> Oyster Creek Generating Station Facility License No. DPR-16 Docket No. 50-219

Subject: Response to Request for Additional Information - Proposed Alternative Repair of Control Rod Drive Housing Interface with Reactor Vessel

Attachment: 1) Response to Request for Additional Information

"Evaluation of the CRD Roll Repair at Oyster Creek"

Figure 2 Roll Band Region

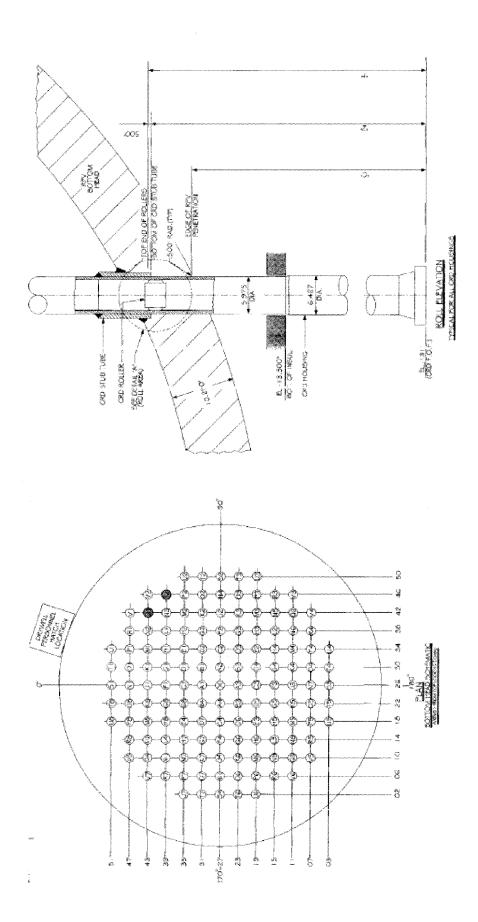
The roll repair at Oyster Creek used a roll band length of 4.5 inches and wall thinning of 6%. Figure 2 shows the schematic of the roll repair detail. Subtracting conservatively the roller end radius (¾ inch) at each end of the roll

band, the roll band length with the full 6% wall thinning is 3 inches. Table 2 shows the CRD scram loads (from Reference 3) for the different plant conditions. The bounding scram load of 13 kips per CRD is used for the determination of the required roll band length.

Substituting F (including the structural factor of 2) = 26 kips, p=0.06, T = 0.5 in and Sy = 30 ksi (Code minimum value at room temperature), the required roll band length is determined to be 1.47 in. The actual roll band length (3 inches after excluding the roll radius region) is in excess of the minimum requirement.
